**ADDENDUM #02 TO THE PLANS, SPECIFICATIONS, AND CONTRACT DOCUMENTS****FOR**

NEW HEALTH SCIENCES BUIDLLING – BID PACKAGE 04  
UNIVERSITY OF LOUISVILLE  
LOUISVILLE, KY

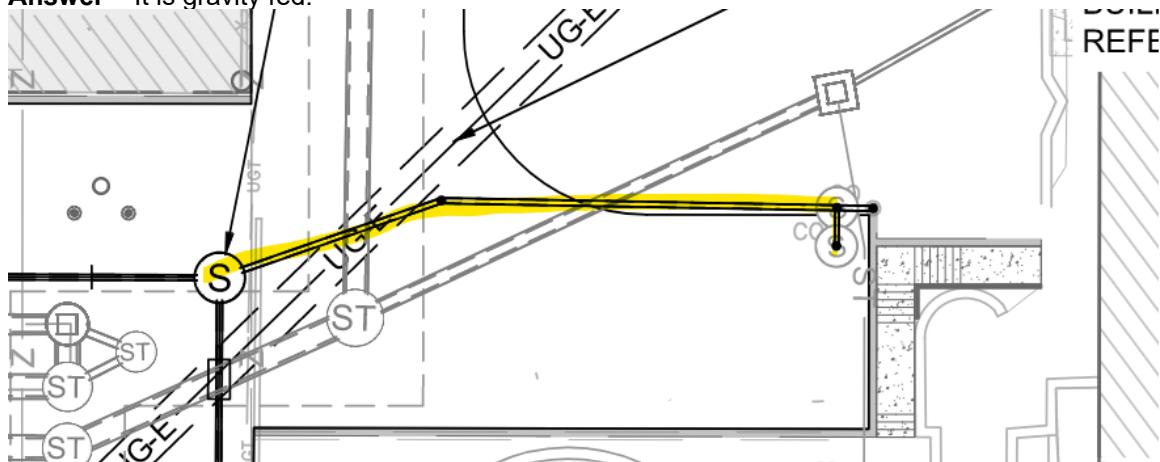
**36. Question** - I didn't see anything in the specifications regarding the grease trap size. Can you confirm what size grease trap should be used?

**Answer** - 250 Gallon

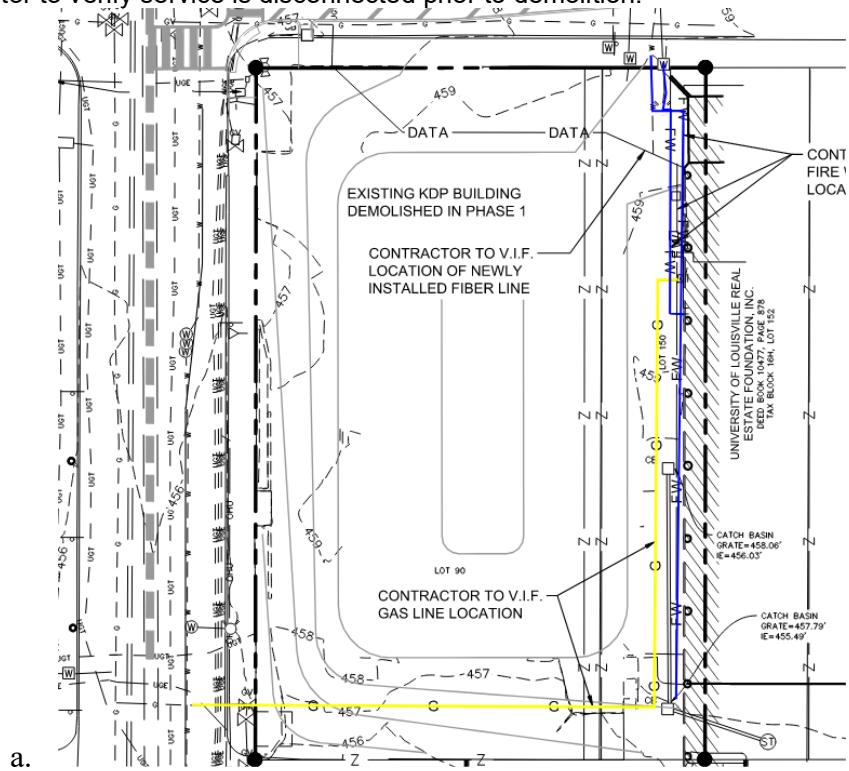
8. BC-01 In addition to the other noted demolition items, add the demolition of the highlighted Gas and Fire Protection Piping below. Coordinate with prior bid package contractor to verify service is disconnected prior to demolition.
